Change notes since last quote (now at Rev D.)

Changes from C to D

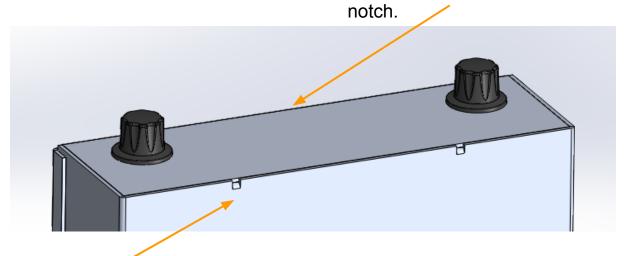
can this edge be overbent slightly to improve fit? the face will then squeeze the

notch is intended to support case wall.

can the notch be formed on the turret punch?
